ADDENDUM 5
To Contract Documents for
EYECARE MEDICAL GROUP
53 SEWALL STREET
PORTLAND, ME 04102

E.M.G. - Phase 2 Addition & Renovation

EYECARE MEDICAL GROUP
PHASE 2 ADDITION AND RENOVATION
ADDENDUM NO. 5
August 9, 2013

FIGURE
C-SK-ADD
5.1

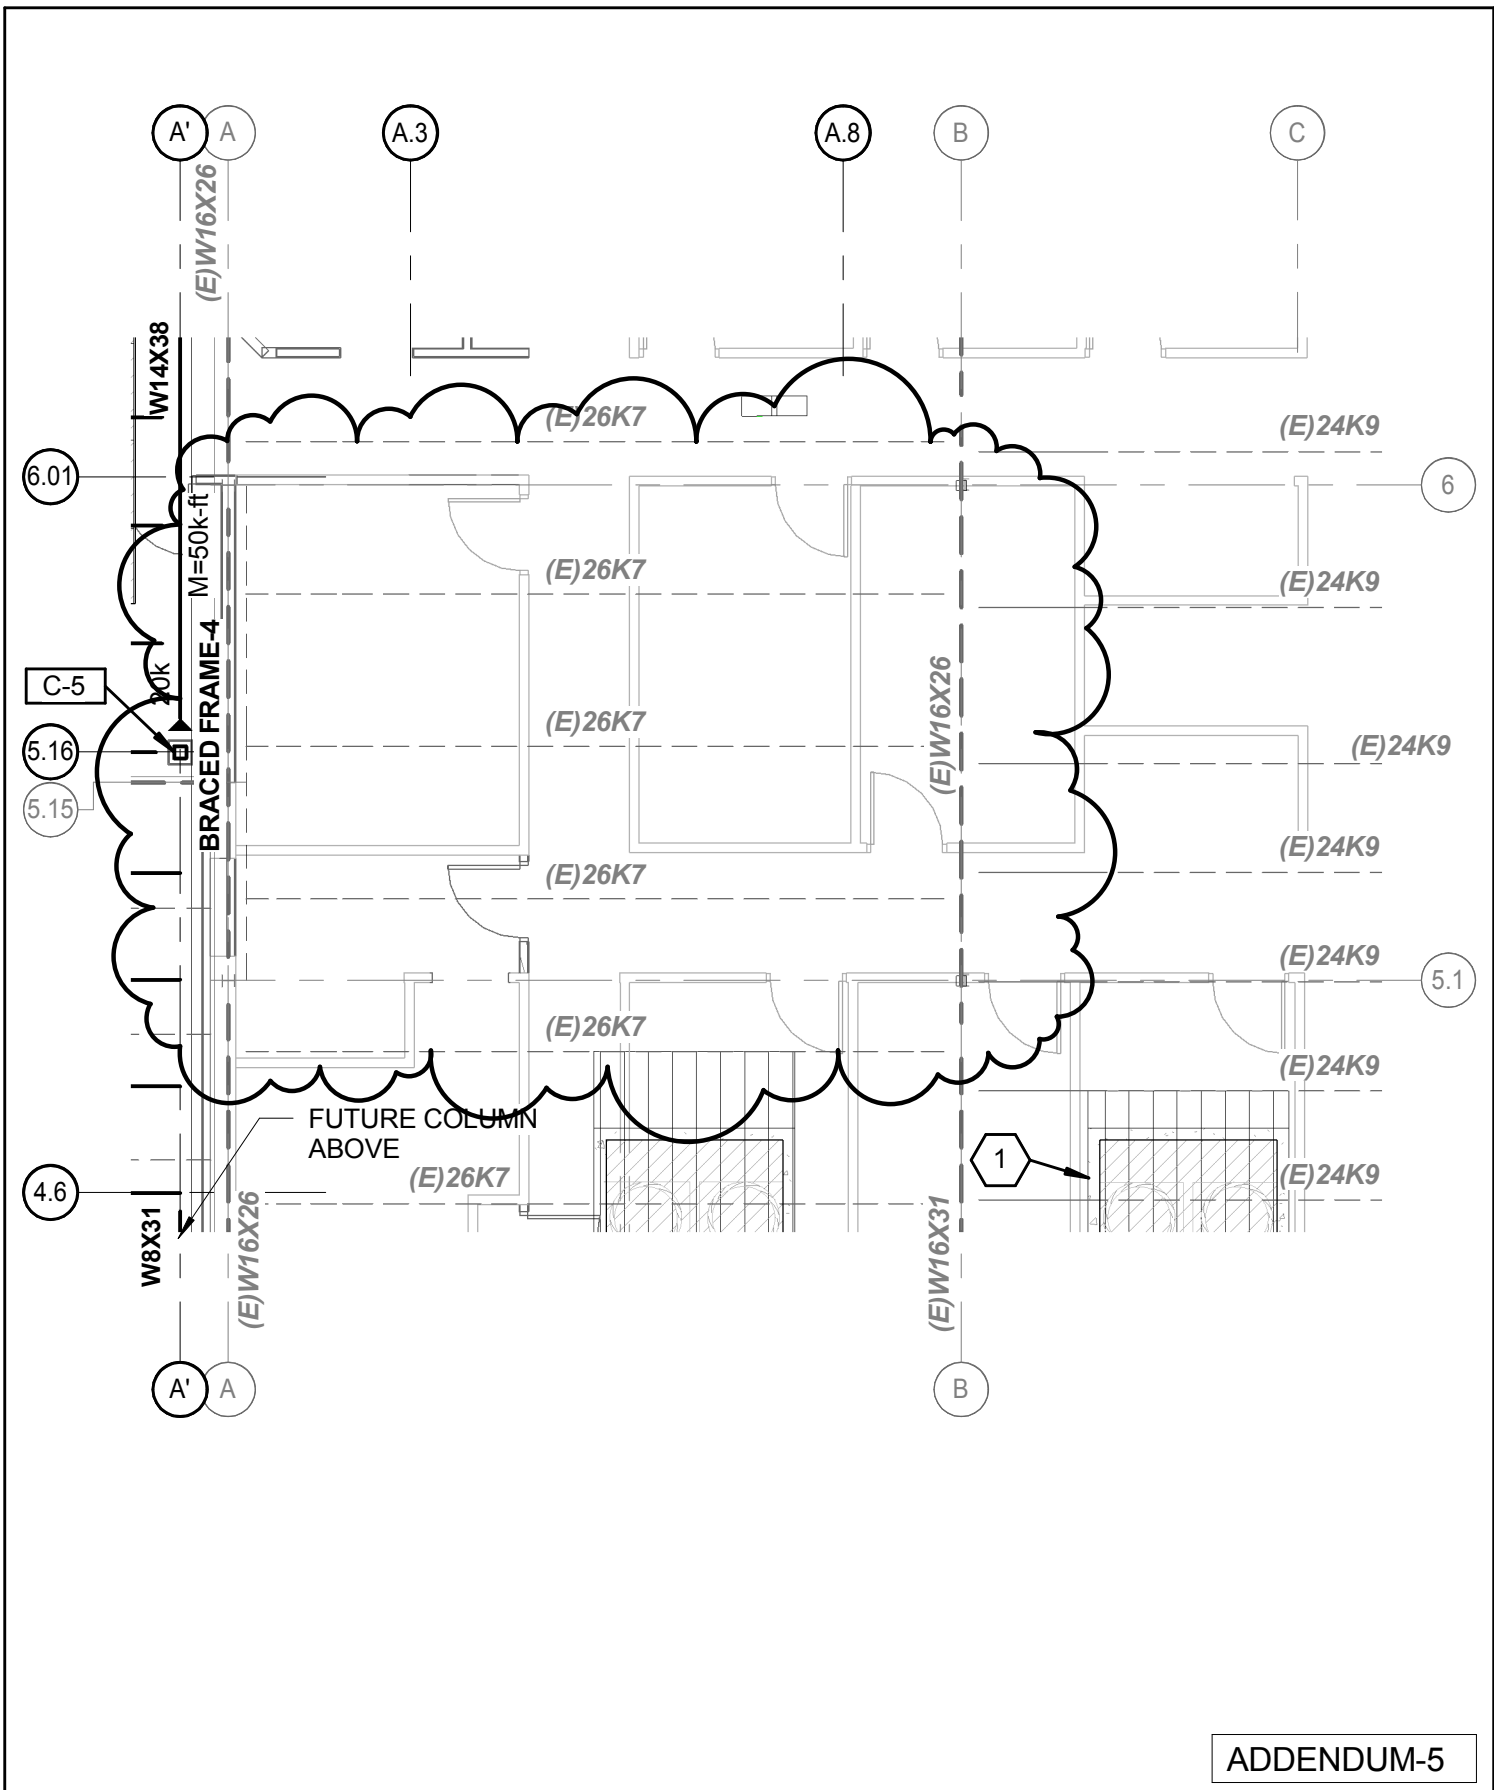
- I. ADD Fabco Stormsok as shown in the attached detail C-SK-ADD 5.I.

SHEET
SKS-12

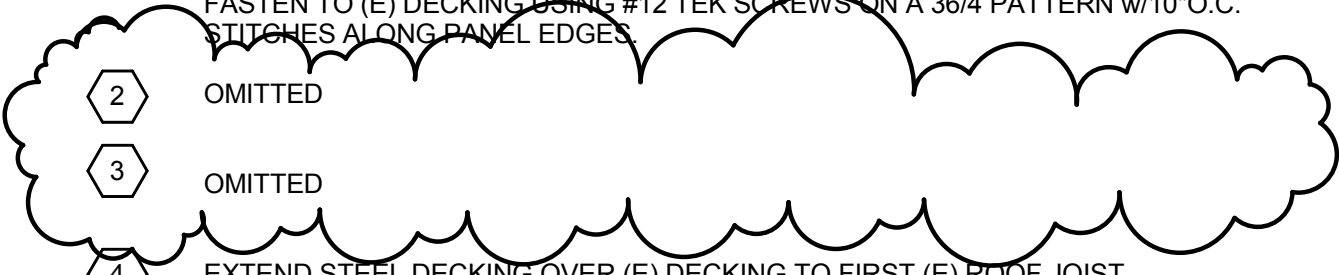
- I. Sheet SF-100: Refer to attached Sketch SKS-I2 for revisions.
2. Sheet SF-100: Refer to attached Sketch SKS-I3 for revisions.
3. Sheet SF-100: Refer to attached Sketch SKS-I4 for revisions.

PROVIDE 24GA. GALVANIZED STEEL DECKING (MATCH EXISTING) SET ON TOP OF (E) DECKING - EXTEND TO NEAREST (E) ROOF JOIST BEYOND EACH END AS SHOWN. PROVIDE 4" CONCRETE SLAB, EXTEND 6" BEYOND UNIT EDGE IN EACH DIRECTION. FASTEN TO (E) DECKING USING #12 TEK SCREWS ON A 36/4 PATTERN w/10"O.C. STITCHES ALONG PANEL EDGES.

SHEET
 SKA-7

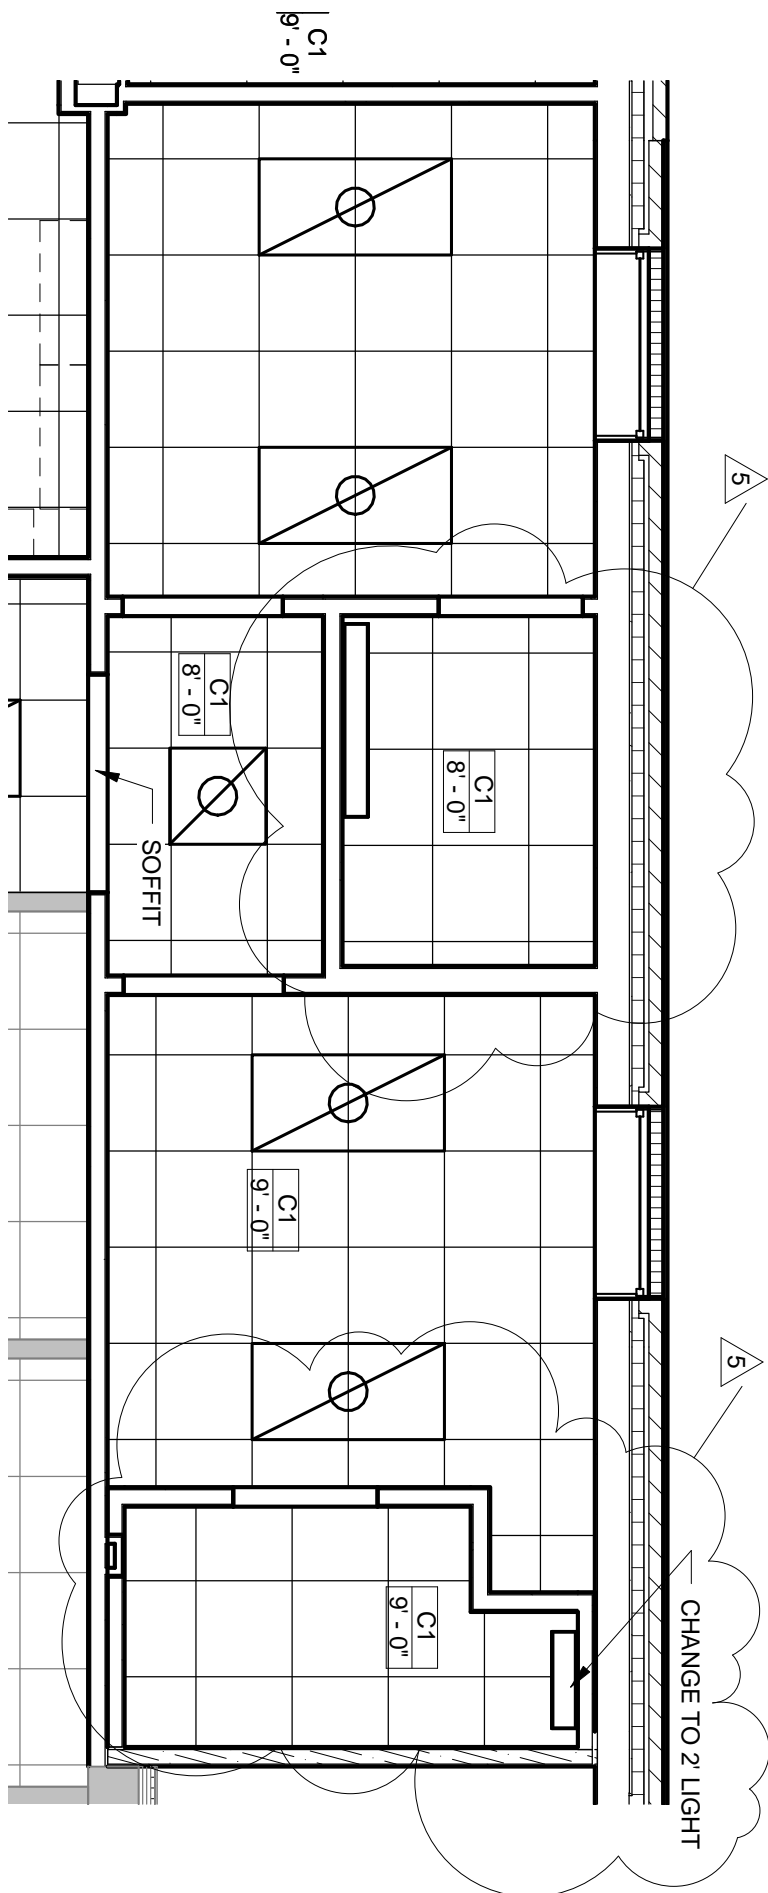
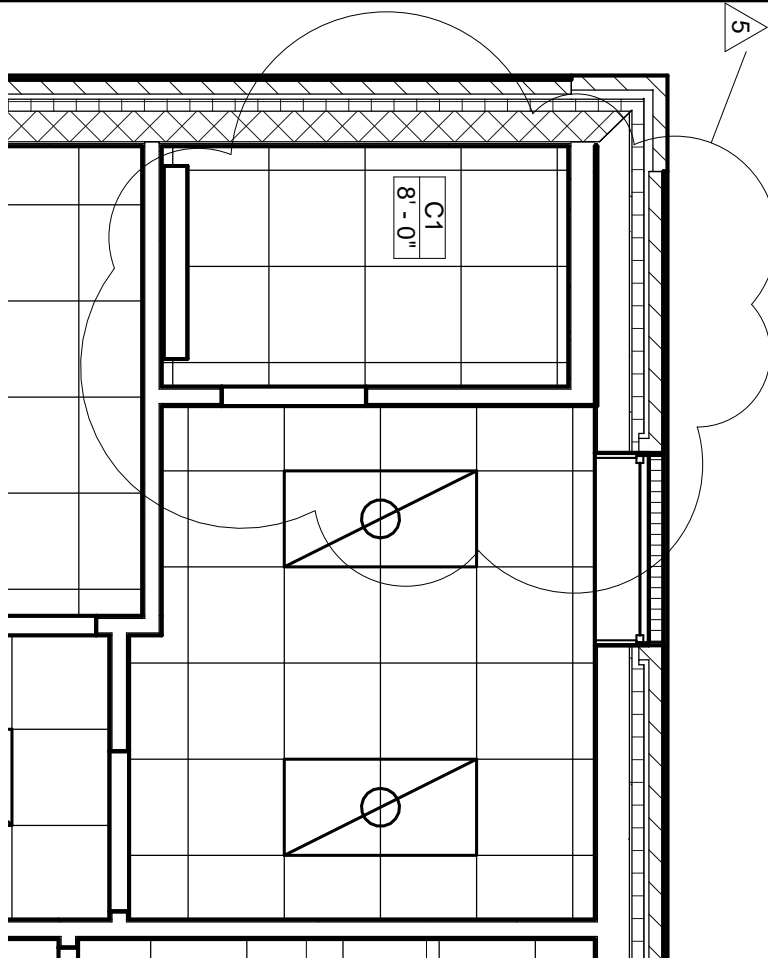
1. CHANGE the layout of Offices I06, I13 & I16 & Toilets I07, I14 & I15 as shown on the attached SKA-7.
2. CHANGE the window location as shown on the attached SKA-7.
3. DELETE the window in the west wall of Office AI06 (now Pvt Tlt AI07) as indicated on the attached SKA-7.
4. Change location of door AI17 for the Gas Room as shown on SKA-9.

SHEET
 SKA-8

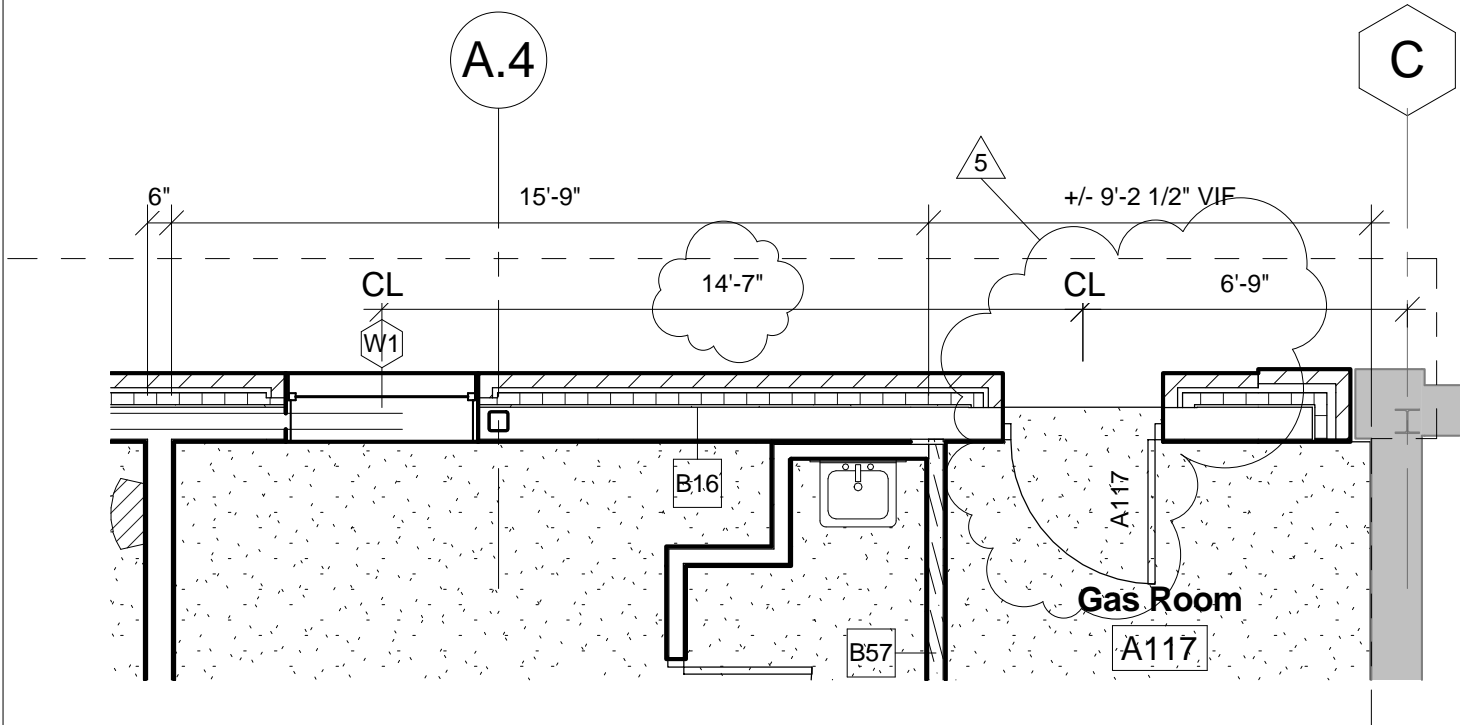
5. CHANGE the ceiling plan and lighting as indicated on the attached SKA-8.
6. CHANGE the linear wall light in Pvt Tlt AI15 to be 2'-0" wide.
7. CHANGE text reading "ALUM. SOFFIT AT EXTERIOR CANOPY" to read "METAL SOFFIT PANELS AT EXTERIOR CANOPY".

SHEET
 SKA-10

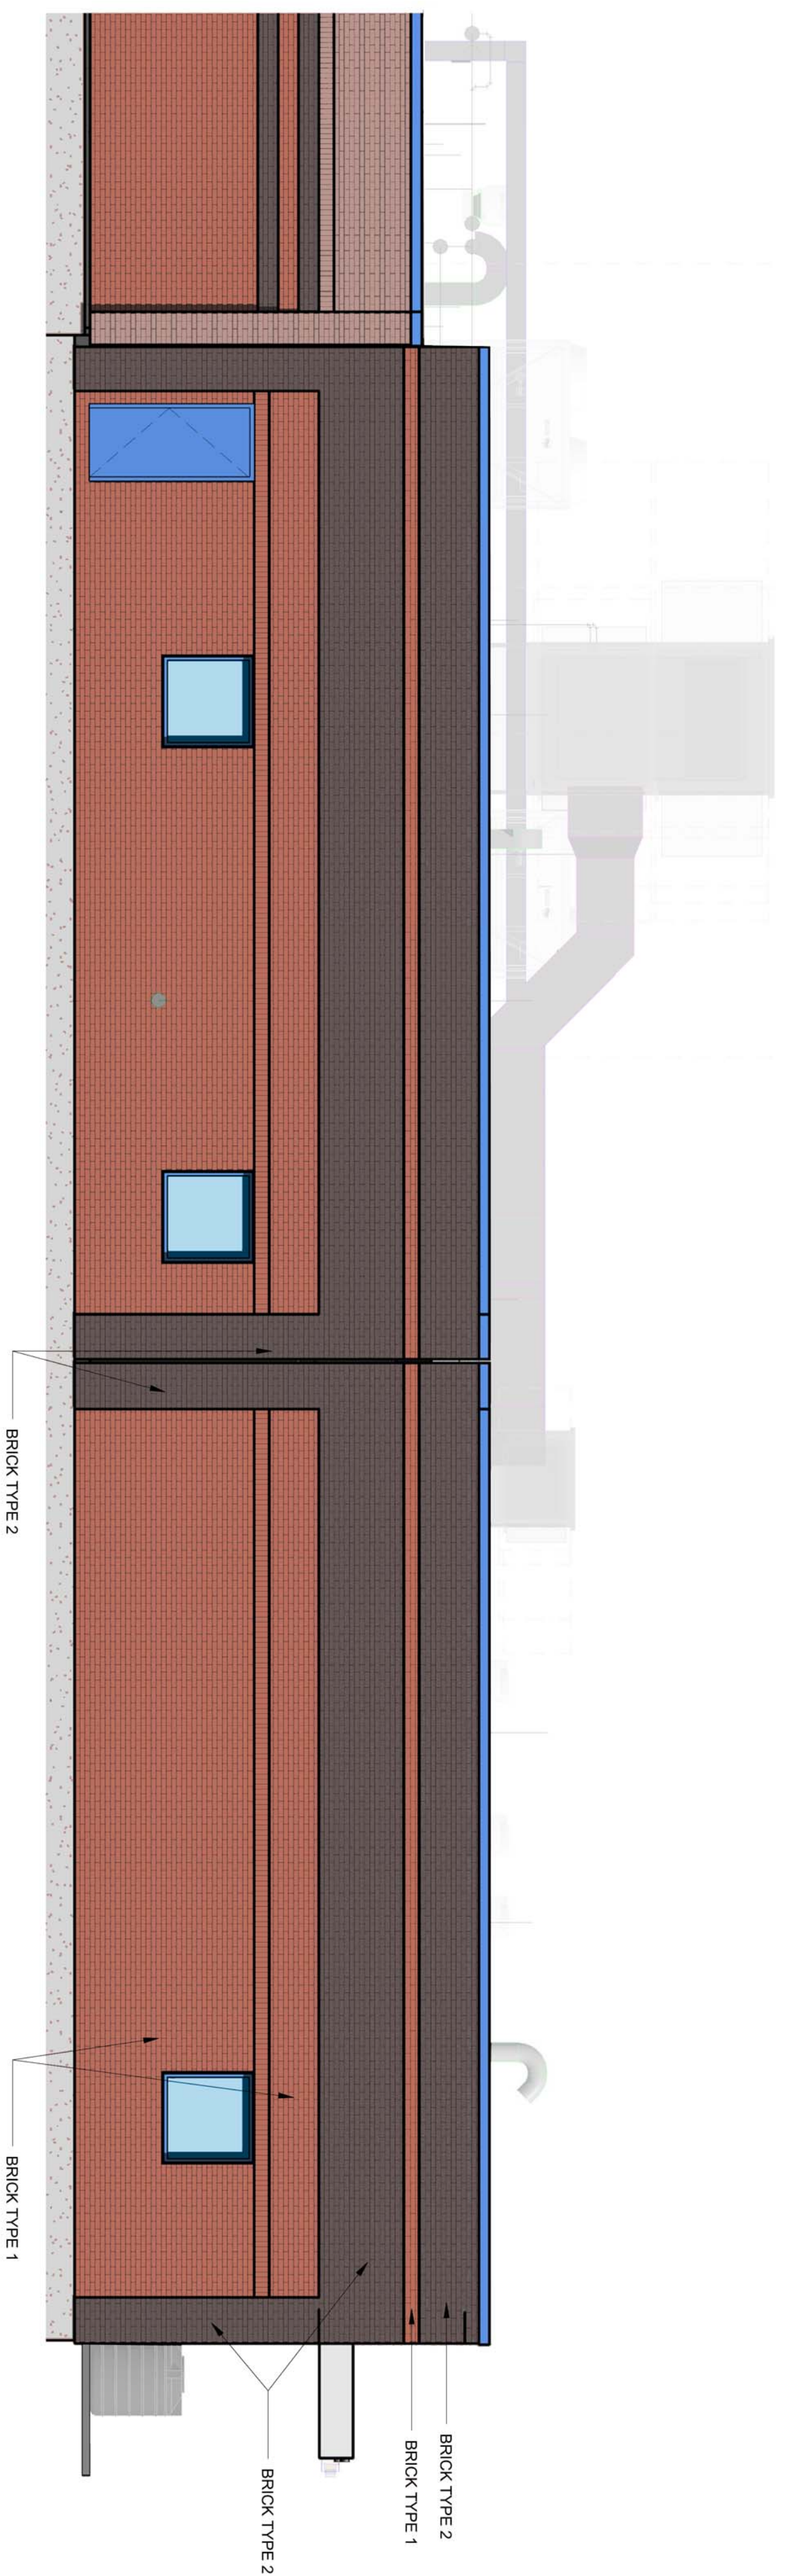
9. ADD pass-through slots at Check-Out AI22, elevation C3/A201, as shown in the attached SKA-10.
10. DELETE all glass at Reception BI01. Delete associated text and graphics on elevations B3, B4, B5, & C1 on A201.

② Rendered View of EXTERIOR ELEVATION NORTH
3/16" = 1'-0"

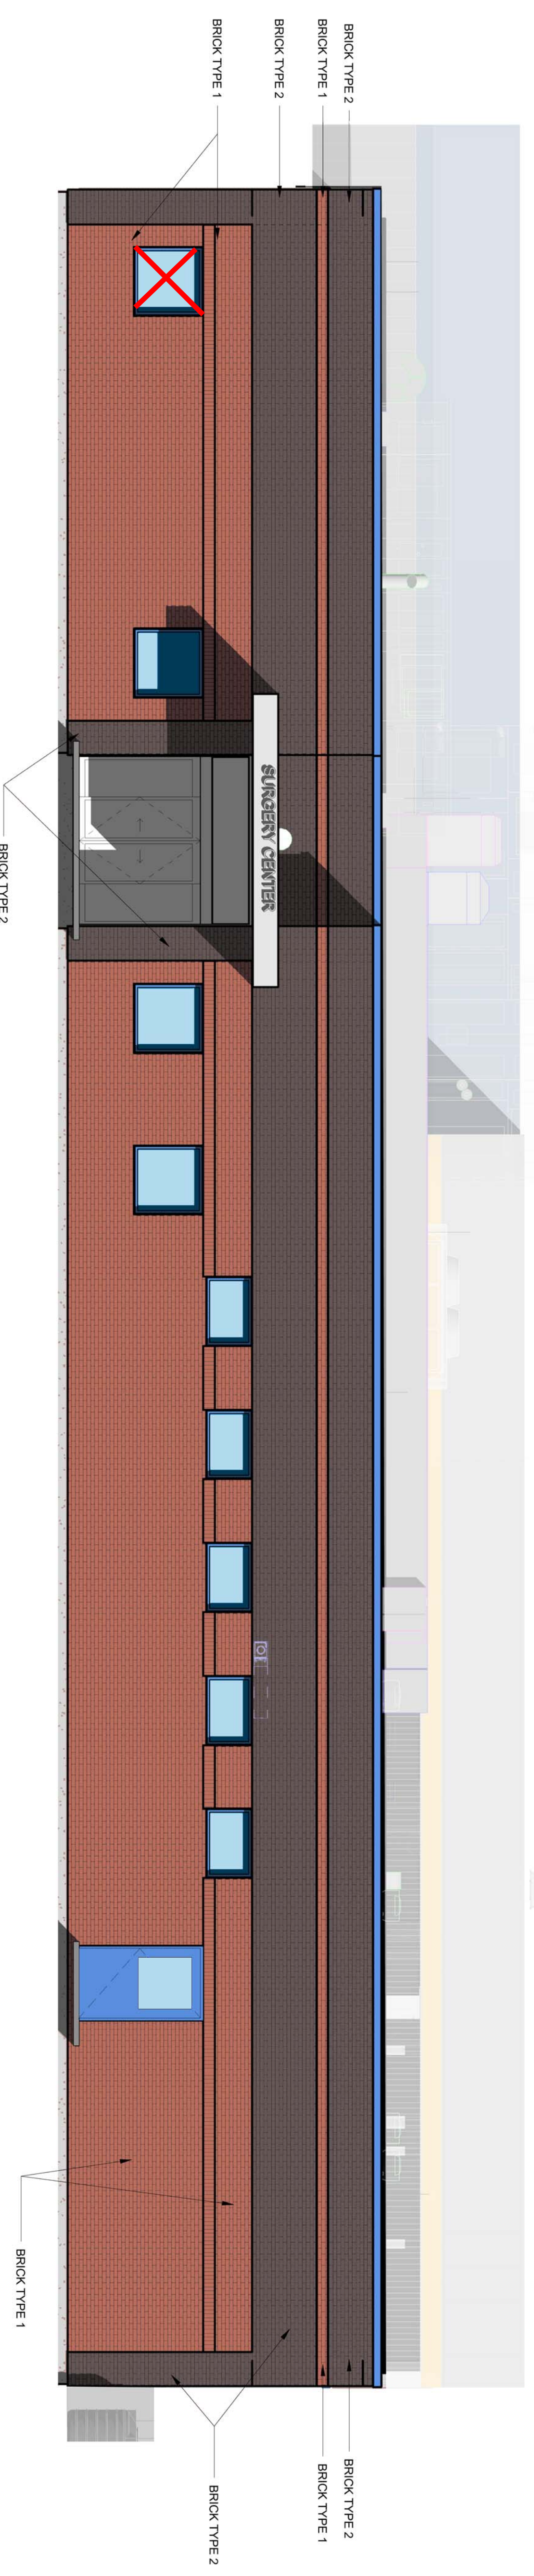
8. Replace sheet A200 with the attached sheet A200. This revises the brick color scheme and deletes the west window in Office AI06. A rendering is attached for reference to brick color scheme only.
